## Stakeholder Comments

### Flexible Ramping Products Incorporating FMM and EIM Straw Proposal

Submitted by	Company	Date Submitted
Aditya Chauhan – (626) 302-3764	Southern California Edison	June 23, 2014

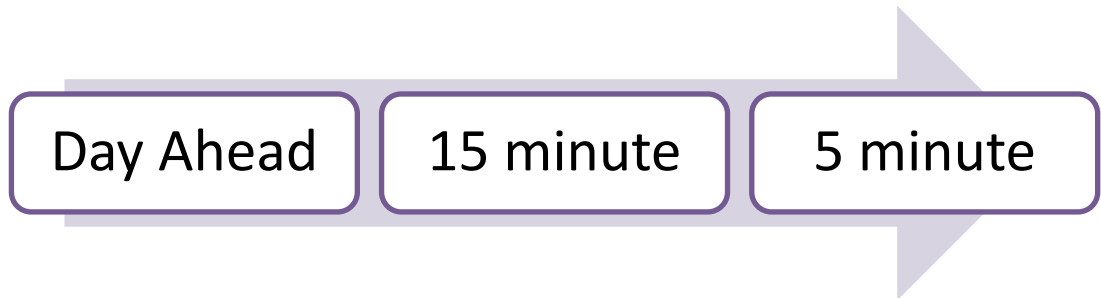
As illustrated above, on any complex design initiative, the CAISO should introduce a formal simulation process before finalizing the design. SCE strongly supports the building of a “sandbox” style Simulation environment. This simulation for FRP should be comprehensive and be an offline model of the entire market process. The CAISO proposal should be completely incorporated through the Simulation design, construction, running, and evaluation. This should be a general approach for any design change – a Simulation that embodies the proposal and is thoroughly evaluated before the actual market proposal is finalized at the Board. The CAISO should use this Simulation environment to test a series of real-world situations (using actual market data where possible) as well as “stress cases” to understand performance under adverse conditions.

The complexity of the CAISO proposal and the lack of transparency on several key elements require a complete Simulation of the entire proposal from DA need determination, all the way to RT cost allocation. Further, there is no clarity on how price formation occurs in this proposal and how it interacts with the myriad market design elements, both existing and proposed. Given the complexity of the proposal, without a simulation, SCE cannot conclude the impact on market price formation will be just and reasonable.

The comprehensive Simulation should transparently show the functioning of the proposal in the Day Ahead, 15 minute, and to the extent possible, the 5 minute time frames. For example, the CAISO proposal on FRP buyback in RT impacts DA as well as RT energy bids. The Simulation will demonstrate the interaction. SCE needs to see how this proposal will impact RT price formation under various real world conditions before SCE can decide if it can support the proposal. The Simulation should thus include actual, historic market data so that prices before and after the design can be compared.
